CITY OF KIRKLAND
PLANNING & BUILDING DEPARTMENT
123 5TH AVENUE, KIRKLAND, WA 98033
425.587.3600 ~ www.kirklandwa.gov

MEMORANDUM

To: Kirkland Hearing Examiner
From: Tony Leavitt, Senior Planner
Thang Nguyen, Transportation Engineer
Adam Weinstein, AICP, SEPA Responsible Official
Date: June 11, 2020
File: **SEP18-00313**
Subject: **APPEAL OF STATE ENVIRONMENTAL POLICY ACT (SEPA)**
DETERMINATION FOR CONTINENTAL DIVIDE MIXED USE PROJECT

Figure 5: AM and PM Peak Hour Trip Assignment

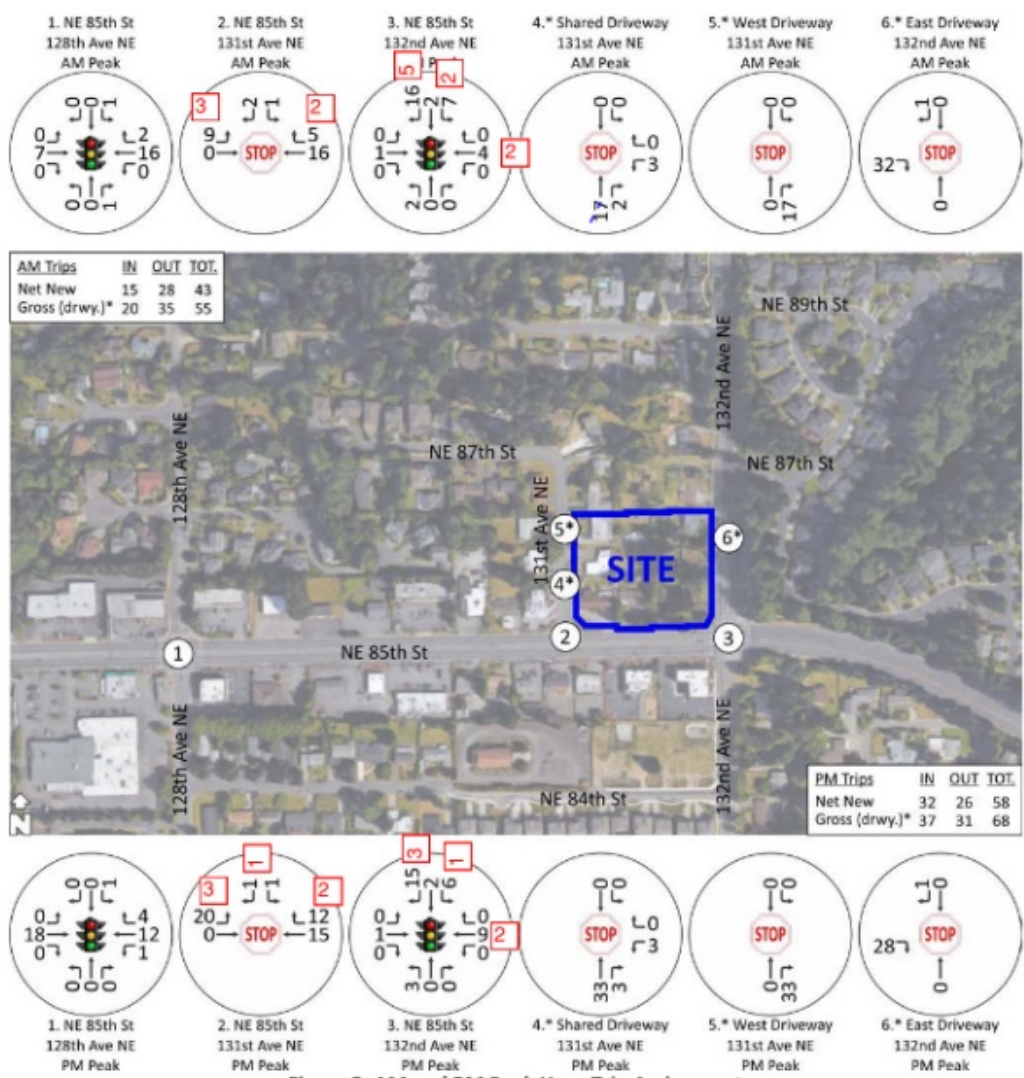
Staff Response: *The morning and evening peak hour trip generation assignment is demonstrated in Figure 5 (see below). There are no errors in Figure 5. However, Figure 5 may not have provided a clear explanation of the project traffic assignment to the appellants. There are asterisks by the driveway volumes (labeled 4, 5, and 6) to note that the driveway volumes represent gross project trips, while the project trips at the off-site intersections (labeled 1, 2, and 3) only present "net new" trips (i.e., proposed development trips minus existing project site trips). Since the driveways are new, there is no way to calculate net new trips at these locations.*

The traffic count data used in the transportation analysis included trips from the previous use at the development site. For proper accounting of the new development's traffic and impact, only net new development traffic is shown at off-site intersections in Figure 5, because the existing traffic counts at the off-site intersections include traffic generated by the previous uses at the site. Those trips must be subtracted out of the development's gross trip assignment (Figure 5) in order to evaluate potential intersection impacts. The figure below provides the project trips (in red) that are accounted within the intersection traffic counts.

If the site was vacant at the time the existing traffic counts were collected, then the traffic analysis would simply show the gross development trips at the off-site intersections, which would be added to the existing traffic counts to develop the traffic volumes for the "future with development" condition.

Figure 13: Garage Parking Profile with Tenants (Residential and Office)

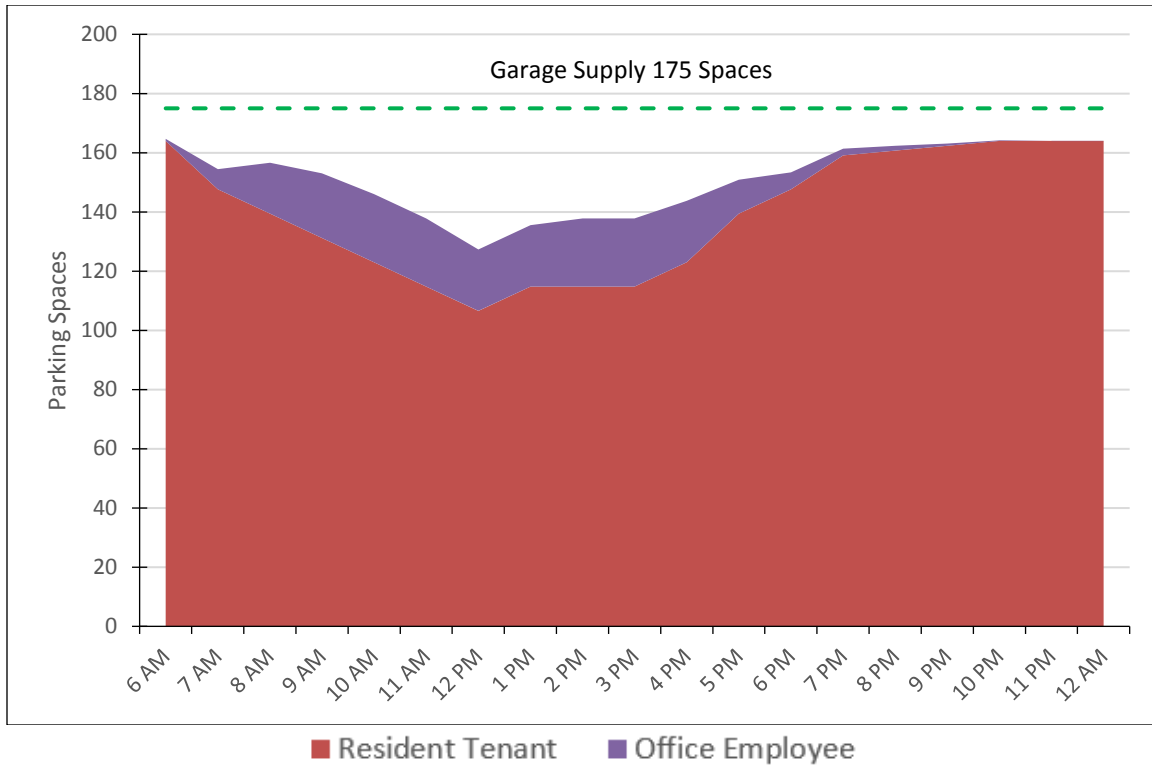
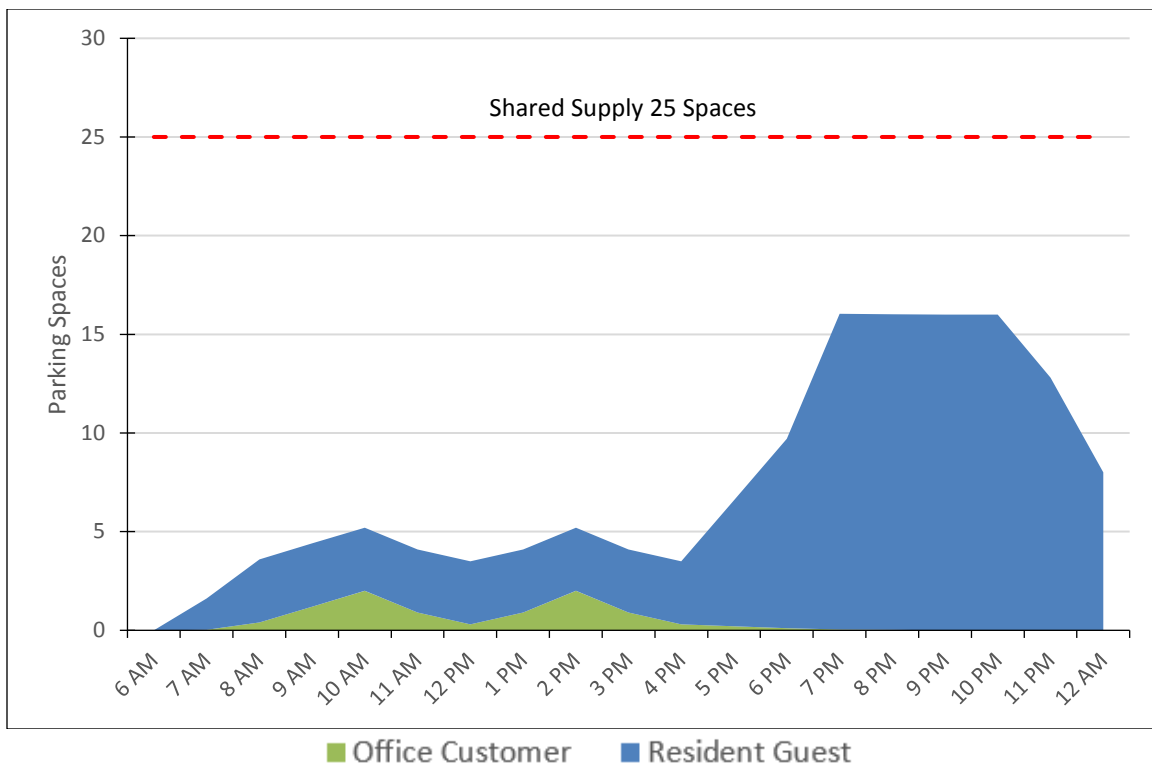
what does LOS have to do with parking? Please explain

Provide a table that shows all the land uses and their parking accumulations and their total on an hourly basis to reflect all the figures presented.

b. Would your project affect the potential use of solar energy by adjacent properties? If so, generally describe.

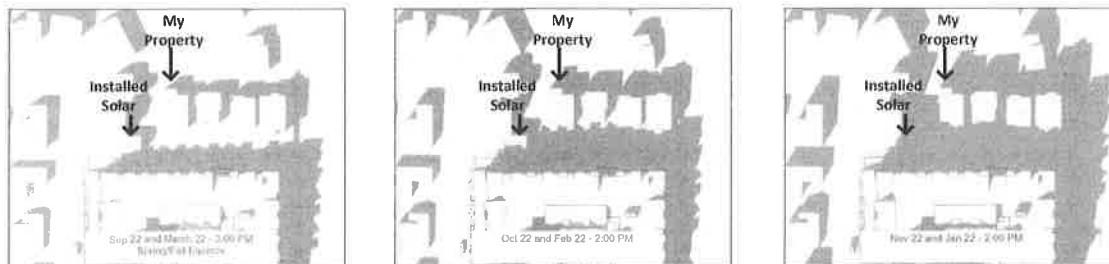
This represents a material misrepresentation of both the applicant's legally required landscape buffer as well as the impact of both the buffer and proposed building on adjacent properties, including my own.

Staff Response: *The City has not adopted specific regulations to address solar access. Here, based upon the developer's agreement to an increased setback of 30 feet from the north property line, the City believes solar access to the north neighbors has not been unreasonably affected. As part of the property rezone in 2015, the Final Environmental Impact Statement (EIS) concluded that the increased height (from 30 feet to 35 feet) was mitigated by the increased setback from the northern property line as noted in the Planning Commission Revisions, Land Use Patterns and Plans and Policies sections (see Attachment 5). This increased setback would also benefit solar access to the north of the project site.*

Erroneous AM new traffic flows
From "Figure 5: AM and PM Peak Hour Trip Assignment",
Page 11

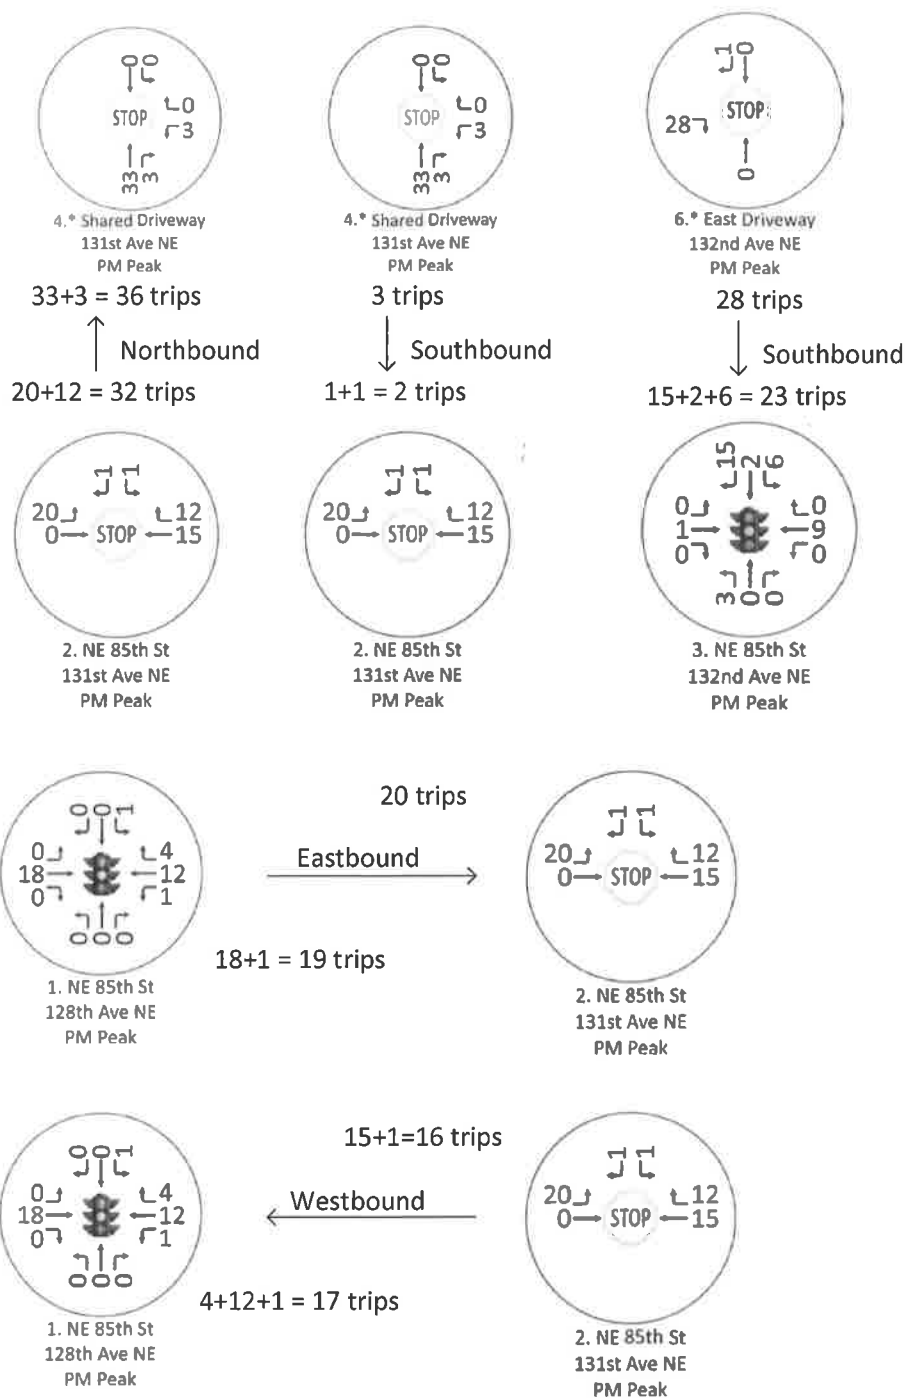
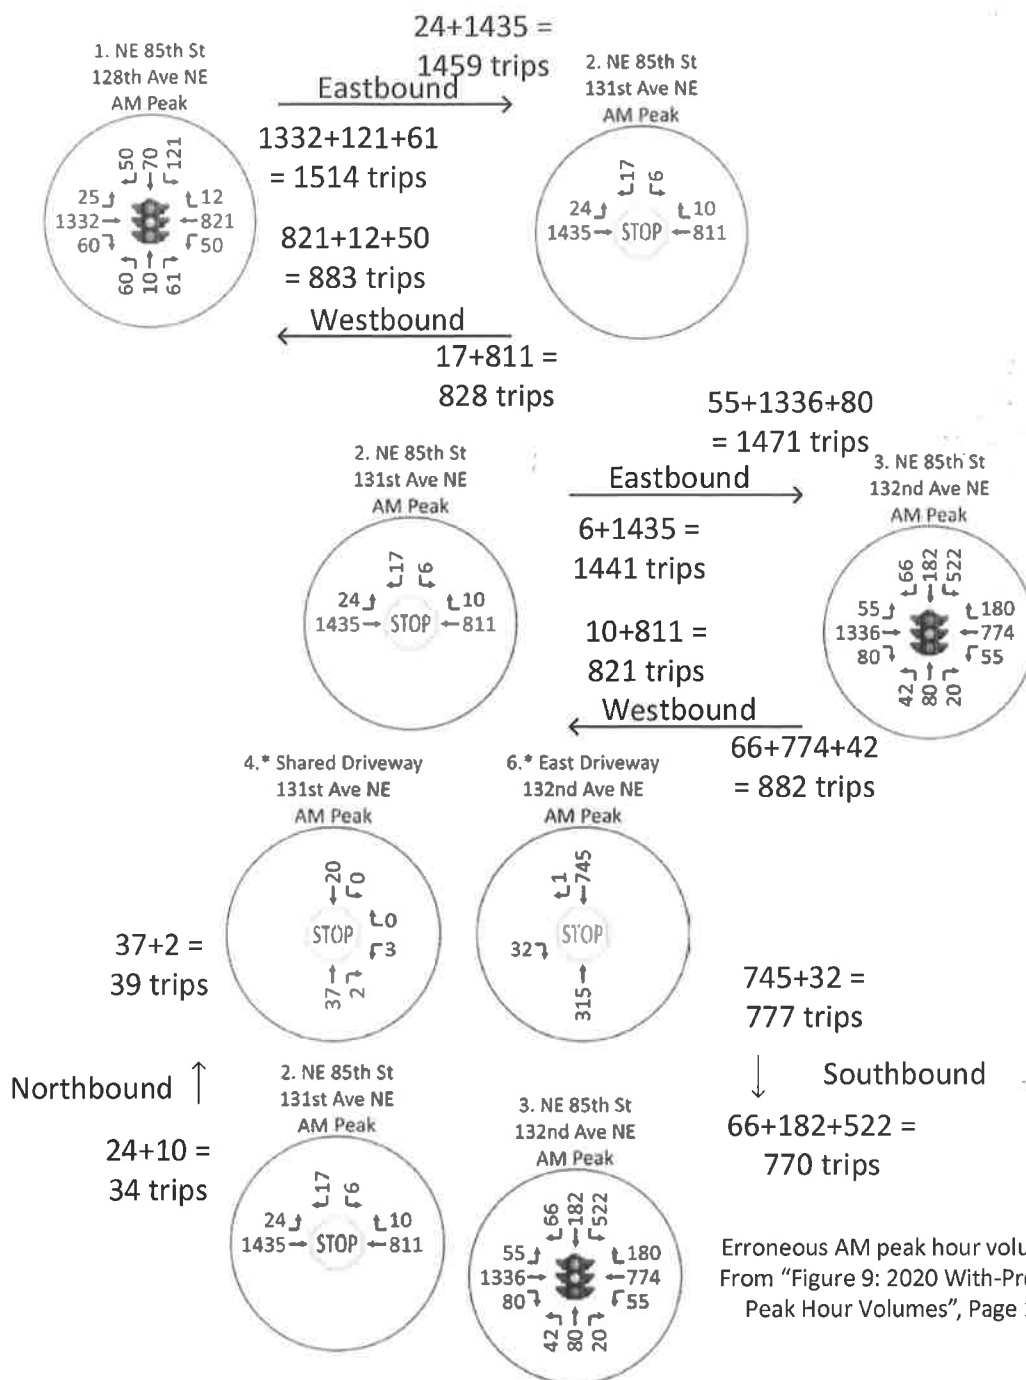
The clearest example of this can be found on Figure 5, page 8. Point 2 is the intersection of NE 85th St & 131st Ave NE. Point 4 is the new proposed shared driveway on 131st Ave NE. No turns are possible in between these two points, every vehicle traveling between these two points must come out of the stretch after going in.

Similar errors exist throughout the assignment of trips in figures 5 (page 8) and figure 9 (page 16). For a comprehensive listing of these errors in both figures see "Appendix – Erroneous calculations in traffic flow".
